Administrative Order SWD-2309
May 11, 2020

**ADMINISTRATIVE ORDER
OF THE OIL CONSERVATION DIVISION**

Pursuant to the provisions of Division Rule 19.15.26.8(B) NMAC, Solaris Water Midstream, LLC (“the Operator”) seeks an administrative order for its Clara Allen SWD No. 1 (“the Proposed Well”) with a location of 275 feet from the North line and 1,000 feet from the East line, Unit Letter A of Section 07, Township 20 South, Range 29 East, NMPM, Eddy County, New Mexico, for the purpose of commercial disposal of produced water.

Attachment: C-108 well completion diagram

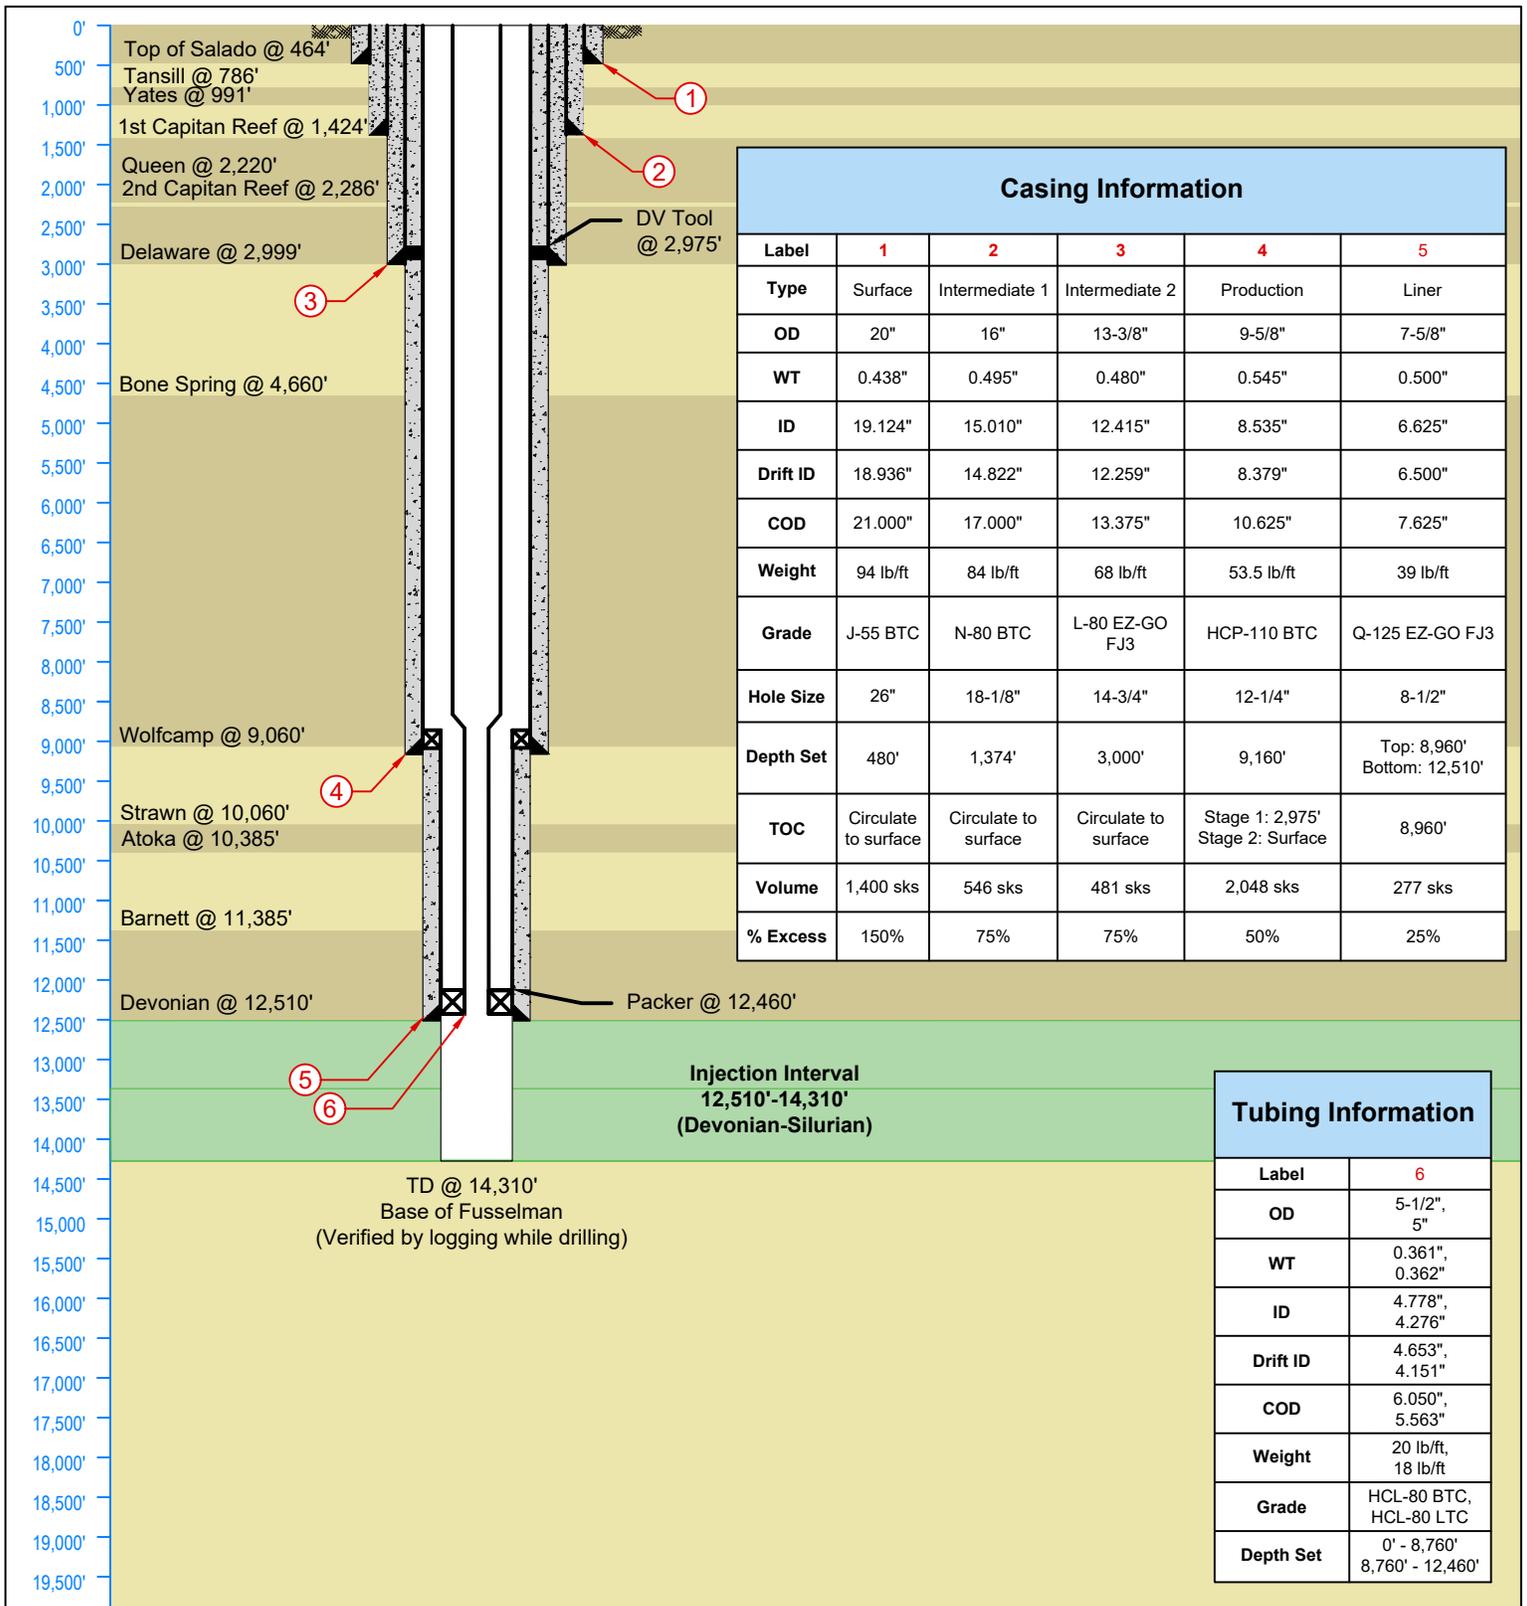
The Operator shall complete the disposal well as proposed in the C-108 application which ensures the isolation and protection of the Capitan Reef aquifer. Any modification of this well construction (excluding adjustments in depths as a result of drilling and logging information) shall require the submission of a Form C-103 Sundry notice of intent and the approval of both the District and the Engineering Bureau Santa Fe prior to initiating the modification. Failure of the operator to provide notice and obtain approval shall result in the loss of authority to inject

The operator shall circulate to surface the cement for the 9 $\frac{5}{8}$ -inch production casing.

If cement does not circulate on any casing string, the operator shall run a cement bond log ("CBL") or other log to determine top of cement and shall notify the Artesia District with the top of cement on the emergency phone number prior to continuing with any further cement activity with the proposed well. If cement did not tie back into the next higher casing shoe, the operator shall perform remedial cement job to bring cement, at a minimum, 200 feet above the next higher casing shoe.

The operator shall run a CBL (or equivalent) for the 7 $\frac{5}{8}$ -inch liner to demonstrate the placement of cement and the cement bond with the tie-in with 9 $\frac{5}{8}$ -inch production casing string. The operator shall provide a copy of the CBL to the Division's District office prior to commencing disposal.

The wellhead injection pressure on the well shall be limited to **no more than 2502 psi**. In addition, the disposal well or system shall be equipped with a pressure limiting device in workable condition which shall, at all times, limit surface tubing pressure to the maximum allowable pressure for this well.
